**Docket:** NRC-2011-0012  
Disposal of Unique Waste Streams

Comments on Proposed Revisions to Part 61

Norman A. Eisenberg, Ph.D.

FIGURE 3.4.1 Toxicity of Spent Fuel and Reprocessing Waste from Uranium-Plutonium Recycle Relative to 0.2% Uranium Ore Necessary to Produce 1 MT of Reactor Fuel

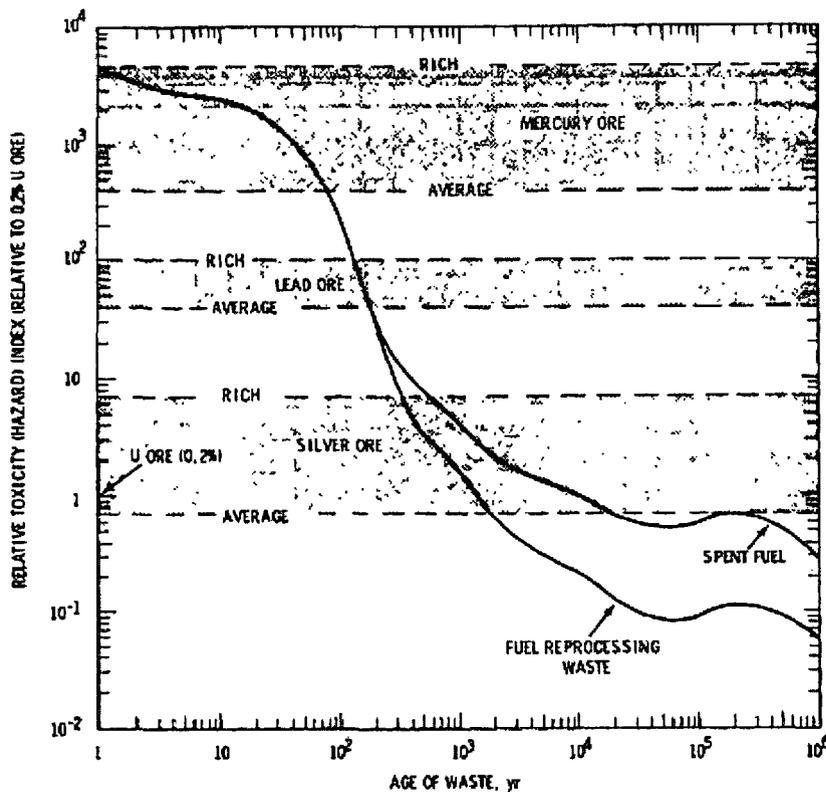
his stated background is geochemistry, not risk analysis or health physics). If the staff wants to address the hazard of depleted uranium over long periods of time, it should employ a concept, such as the "hazard index" used in the document, *FEIS Management of Commercially Generated Radioactive Waste*<sup>1</sup>. Figure 3.4.1 from the cited report is

reproduced here. The hazard index defined in this document is ‘based on the amount of water required to bring the concentration of a substance to allowable drinking water standards’. In other words, it is the quantity of a particular radionuclide divided by the concentration limit for that radionuclide established for drinking water. As such, this “hazard index”<sup>2</sup> has the unit of volume, often stated as m<sup>3</sup>. Note that in Figure 3.4.1, the ingrowth of progeny in the “natural ore body” is not considered, but the ore body is presumed to remain at the same concentration of natural uranium for all time, even though it will not.

1. Delete the graph of radioactivity vs. time (Figure 1) from the White Paper and replace it with a graph depicting the time-varying nature of the hazard of depleted uranium; e.g. use the "hazard index" defined in DOE's EIS on Commercially-Generated Radioactive Waste.
